SAFETY EVALUATION BY THE OFFICE OF NUCLEAR REACTOR REGULATION

STEAM GENERATOR INSPECTION PROGRAM AND RETURN TO POWER REPORT (SEPT. 1982)

SAN ONOFRE NUCLEAR GENERATING STATION, UNIT NO. 1

DOCKET NO. 50-206

Figure 1  
 LOCATIONS EVALUATED FOR SLB AND SSE

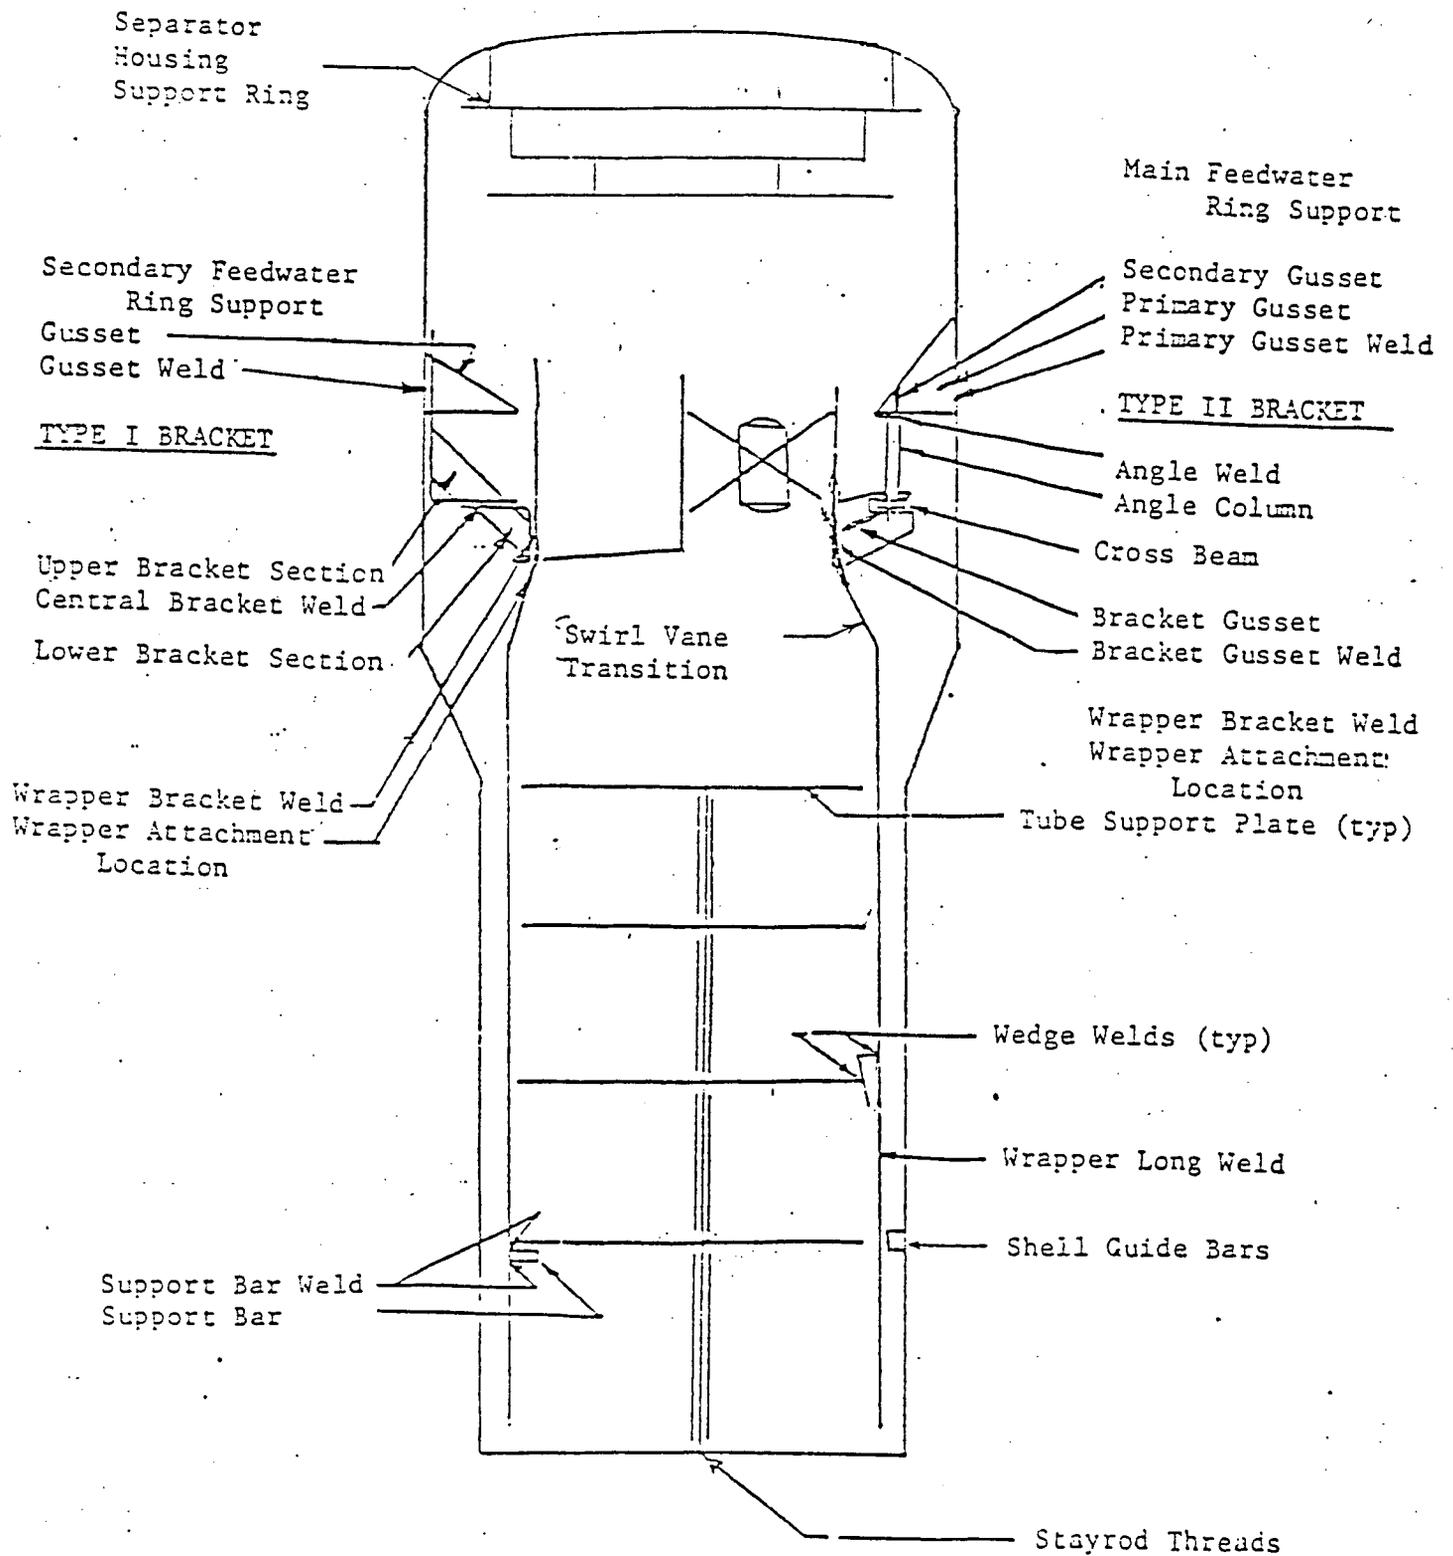
The Westinghouse analysis demonstrates that under the assumed conditions the internals behave so as to not affect the structural integrity of the primary pressure boundary. A summary of the Westinghouse analysis results are provided in Table 1. The location of each of the regions included in these analyses is presented in Figure 1.
